# Proposal to modify the SRS test for 100GBASE-DR

In support of comment i-78  
David Lewis, Lumentum

# Minimum Transmit OMA varies with TDECQ

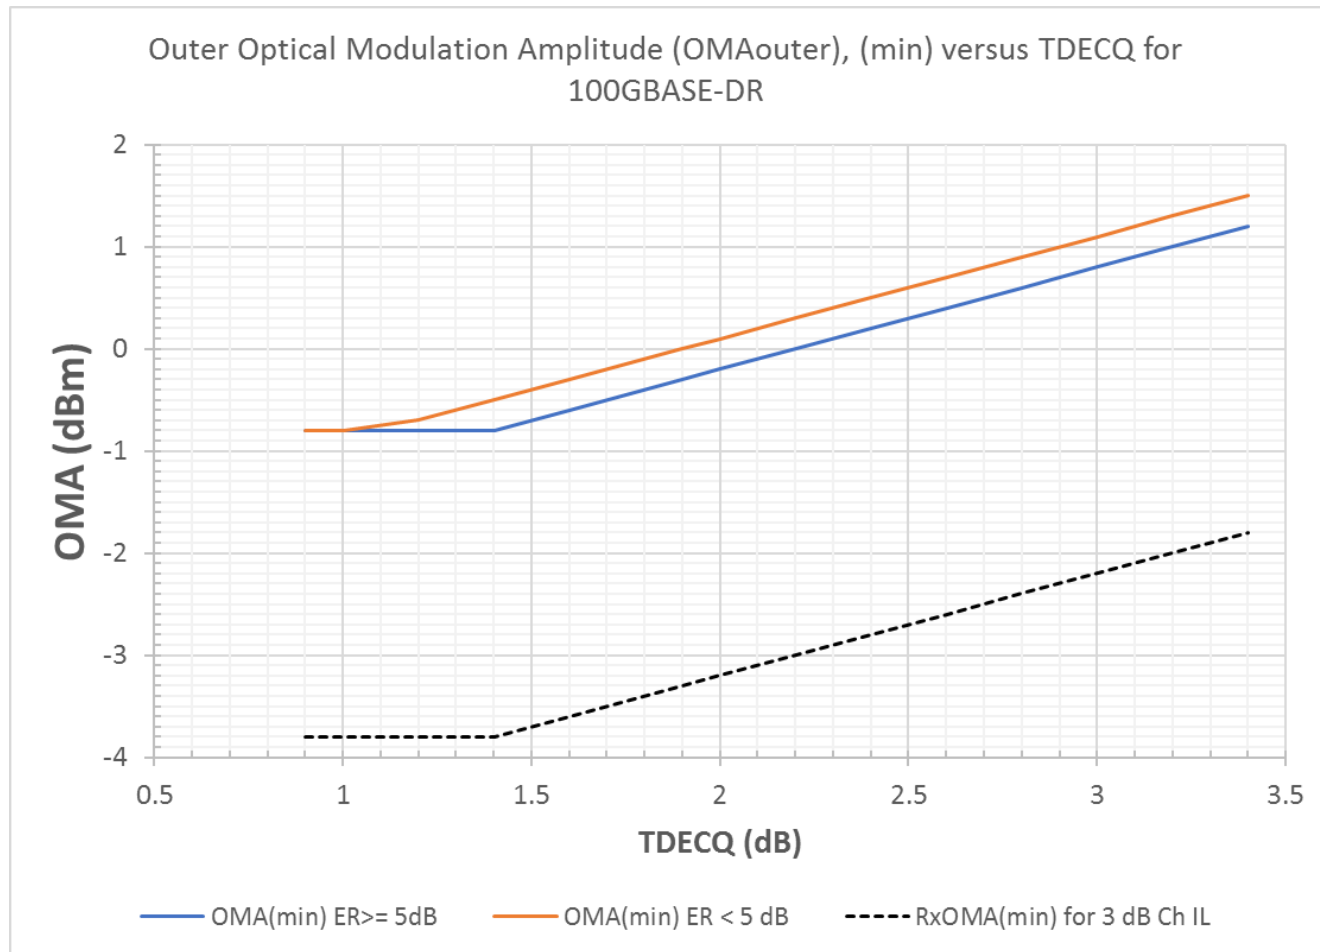
# OMA (min) at the receiver input (TP3) varies depending on the transmitter TDECQ

# Receiver test is only required at SECQ of 3.4 dB

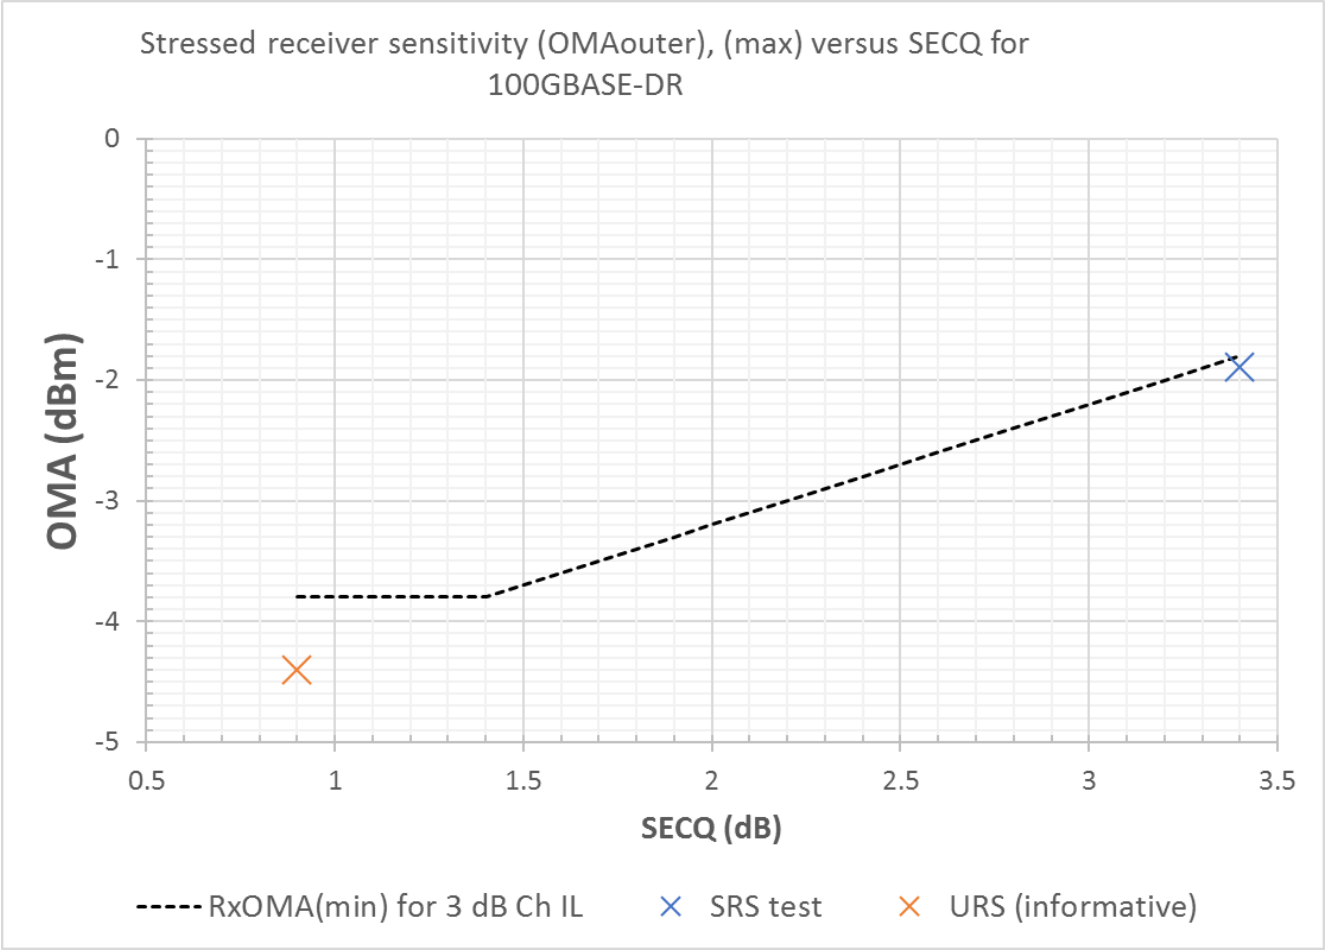
# SRS test verifies that receiver meets BER requirements for a worst case transmitter

- With TDECQ max of 3.4 dB, a real receiver can see input OMA of 2 dB lower than the SRS test limit.
- Real receivers need to demonstrate that they meet the BER threshold at RxOMA lower than the signal supplied by a good transmitter (TDECQ  $\leq$  1.4 dB)
- Proposal of comment i-78 is to add that requirement to the SRS test by allowing SECQ to vary between 0.9 and 3.4 dB and requiring real receivers to demonstrate they are below the mask in Figure XX (next page)
